CMD: 24-H2

Determination for

**Ontario Power  
Generation (OPG), Inc.**

**Darlington New Nuclear  
Project (DNNP)**

**Figure 1: Comparison between the EA bounding reactor scenario and estimated BWRX-300 radiological emissions to atmosphere for a four-unit deployment (airborne releases)**

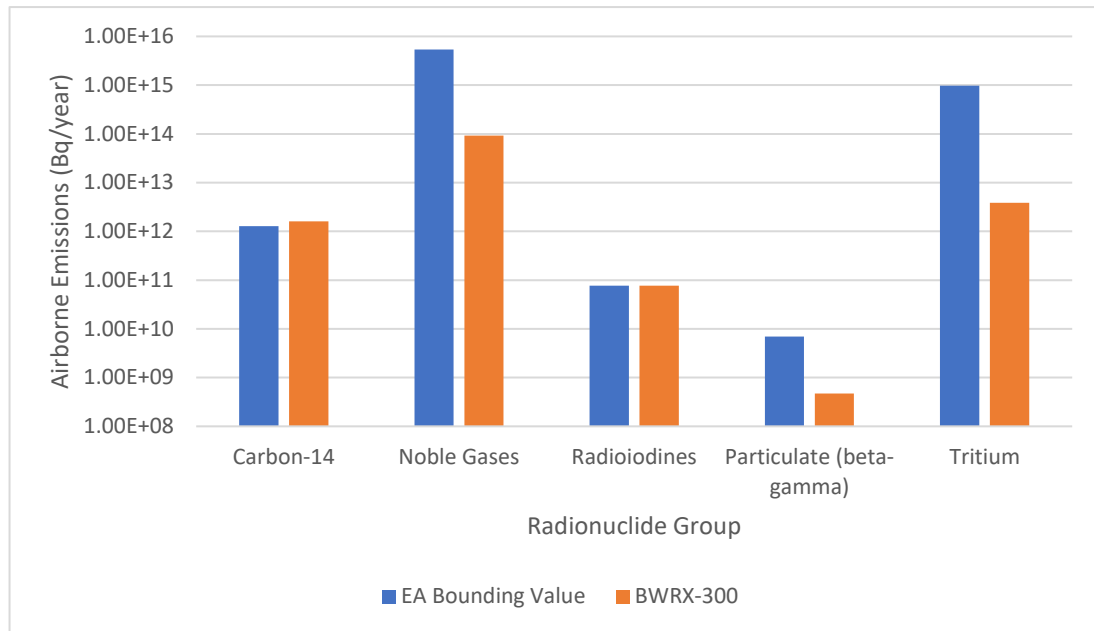
Figure 1 provides a comparison between airborne releases to the environment documented in the EA and estimated for the four-unit deployment of the BWRX-300 reactors.

OPG conducted a study to compare the effect of these release parameters to those assessed in the EA, and to determine whether the change in emission values (e.g., those for airborne radioiodines) remained within the bounding dose to a member of the public assessed in the EA. OPG calculated radiological doses to members of the public [13] using modelling consistent with the existing nuclear facilities, including the default parameters identified in CSA standard N288.1 – *Guidelines for Modelling Radionuclide Environmental Transport, Fate, and Exposure Associated with the Normal Operation of Nuclear Facilities* (2020 edition) [14].

CNSC staff provide further discussion on expected dose to members of the public from these releases in subsection [2.2.2.9.1 – Physical Well-Being](#) of this CMD.

**Figure 2: Comparison of occupational radiation dose to NEWs from the deployment of a single-unit and multi-unit BWRX-300 and the dose assessed in the EA**

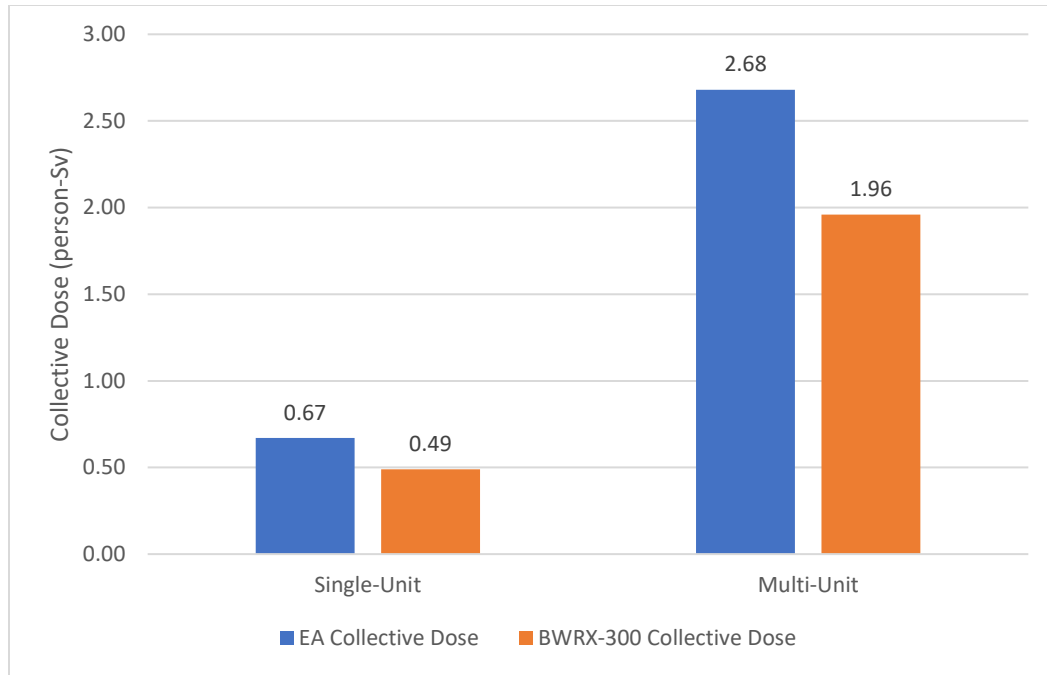
Figure 2 below provides a comparison of occupational exposure to NEWs between the bounding scenario assessed in the EA and the deployment of the BWRX-300 reactors, for both a single-unit and up to four reactors.

Radiological doses to NEWs from a multi-unit BWRX-300 deployment are predicted to be within the regulatory dose limits in sections 13 and 14 of the *Radiation Protection Regulations* during normal operations and maintenance outages, and controlled consistent with subsection 4(1) of the *Radiation Protection Regulations*. This prediction continues to be within the bounds of the EA.
